Access Compliance Report Public Rights-of-Way (Curb Ramps)

Main Street: EDENDALE_ST Cross Street: WYNDHAM_ST Location: W

ADA ID: RPRK211020152652 Ramp Type: Type 4 - Parallel Initial Pass/Fail: Pass Overall Compliance: No Severity Score: 25

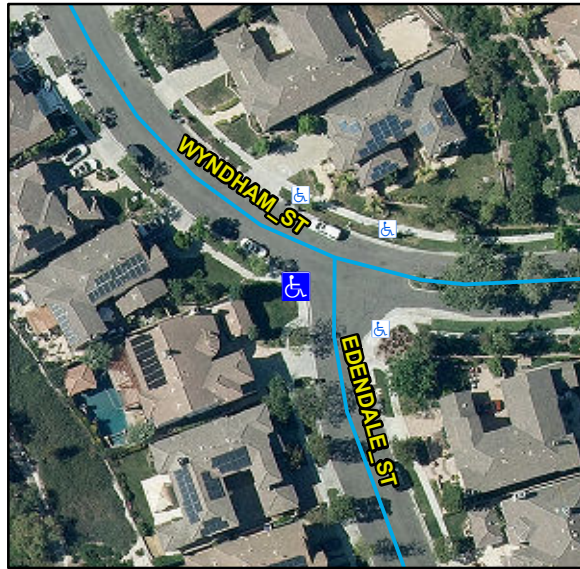
Crossing 1 Slope (%)	3.9		Crossing 2 Slope (%)	2
	Crossing 1 Cross Slope (%)	0.9		Crossing 2 Cross Slope (%)	2.5
Yes	Gutter Ponding	No	Yes	Curb Slope	5.7
Yes	Gutter Lip Height (in)	0		Road Run Slope (%)	2.5
No	Gutter Run Slope (%)	7.6		Road Cross Slope (%)	3.7
Yes	Gutter Cross Slope (%)	0.9	No	Perpendicular Joint Present	No
Yes	Overall Surface Condition	Acceptable			
	Cross Gutter Present?	No		Spandrel Present?	No
	Replace Cross Gutter?	N/A		Replace Spandrel?	N/A

Remove & Replace Curb Ramp With Two New Directional Ramps or Equivalent. Remove & Replace Gutter.
